Feedback report

RPAG Meeting

- Monday, March 25, 2024, 12:00 p.m. - 4:00 p.m.
- Virtual webinar hosted by PSE and facilitated by Triangle Associates
- Links to:
 - [Presentation](#)
 - [Meeting recording](#)

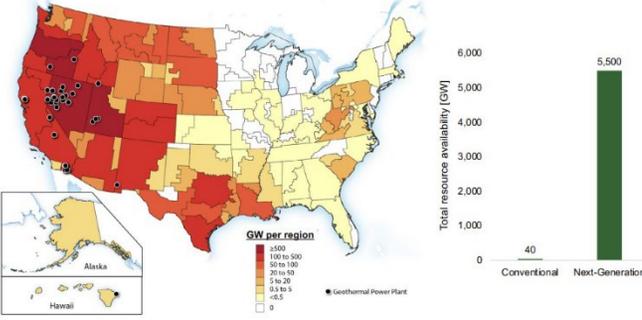
</div> <p data-bbox="781 634 1419 755">Our chart (previous page) shows the estimated cost of CAPEX and O&M for an SMR (\$12,368/KW) is more than <i>quintuple</i> the median cost of these 15 technologies (\$2,373/KW).</p> <p data-bbox="781 787 1419 1182">Are the cost estimates for SMRs realistic? Black and Veatch provided scant detail on how their estimates were developed, and PSE provided no link to the consultant’s report. No RPAG member asked any probing questions about the SMR cost estimates. However, in March 2023, X-energy updated its cost estimates as part of the Department of Energy’s Advanced Reactor Demonstration program. The company said the CAPEX cost of a four-unit project with a capacity of 320 MWe would be \$4.75-\$5.75 billion, or \$14,844/KW to \$17,969/KW. This is significantly higher than Black and Veatch’s estimate of \$10,368/KW (CAPEX only).</p> <p data-bbox="781 1214 1419 1451">If ratepayers will be required to pay for SMR plants, we ask for greater clarity on the cost and schedule risks. Aside from exorbitant CAPEX costs, the high (and uncertain) O&M cost for a baseload resource is an additional concern. On slides 50 and 51, PSE assumes SMRs would provide baseload electricity with a 93% capacity factor. Such operation would overlap hours of the day and seasons where much</p>	Technology	CAPEX (\$/KW)	Fixed O&M (20-yr)	Total Cost (\$/KW)	Thermal Peaker (NG/REG)	~1000	~1000	~2000	Thermal Peaker (H2)	~1000	~1000	~2000	Wind	~1000	~1000	~2000	PV Solar + BESS	~1000	~1000	~2000	BESS	~1000	~1000	~2000	AA-CAES	~1000	~1000	~2000	LOES iron-air battery	~1000	~1000	~2000	Wind + BESS	~1000	~1000	~2000	PV Solar + Wind + BESS	~1000	~1000	~2000	DER solar PV	~1000	~1000	~2000	DER BESS	~1000	~1000	~2000	Offshore wind (fixed)	~1000	~1000	~2000	Offshore wind (floating)	~1000	~1000	~2000	Nuclear SMR	~10,000	~2,368	~12,368	
Technology	CAPEX (\$/KW)	Fixed O&M (20-yr)	Total Cost (\$/KW)																																																														
Thermal Peaker (NG/REG)	~1000	~1000	~2000																																																														
Thermal Peaker (H2)	~1000	~1000	~2000																																																														
Wind	~1000	~1000	~2000																																																														
PV Solar + BESS	~1000	~1000	~2000																																																														
BESS	~1000	~1000	~2000																																																														
AA-CAES	~1000	~1000	~2000																																																														
LOES iron-air battery	~1000	~1000	~2000																																																														
Wind + BESS	~1000	~1000	~2000																																																														
PV Solar + Wind + BESS	~1000	~1000	~2000																																																														
DER solar PV	~1000	~1000	~2000																																																														
DER BESS	~1000	~1000	~2000																																																														
Offshore wind (fixed)	~1000	~1000	~2000																																																														
Offshore wind (floating)	~1000	~1000	~2000																																																														
Nuclear SMR	~10,000	~2,368	~12,368

Figure 8. Geothermal deployment over time across the U.S. in 2030 (light green), 2040 (middle green), and 2050 (dark green) based on the "Energy Earthshot Original" modeling scenario. See Appendix A for details.

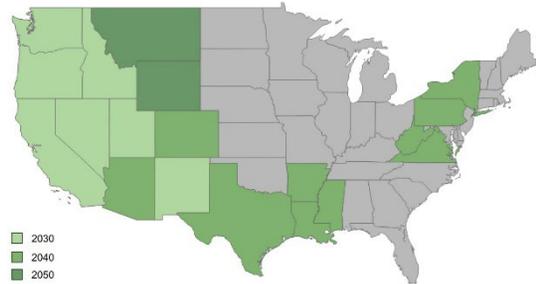
No.	Date	Interested party	Submitted via	Question or comment	PSE response
				<p data-bbox="772 250 1134 267">Next-generation and conventional geothermal resource estimates</p>  <p data-bbox="772 625 1417 669">Figure 2: [Left panel] Total next-generation potential across the United States (red shading), overlain by locations of current conventional geothermal plants producing 3.7 GW of power (black dots). [Right panel] comparison between total available resource for conventional geothermal (left) and next-generation geothermal (right).</p> <ul data-bbox="940 717 1365 993" style="list-style-type: none"> ○ Figure 8 shows the potential extent of next-generation geothermal deployment in 2030, 2040, and 2050. Washington state is one of seven states identified with the potential to deploy next-generation geothermal in 2030.
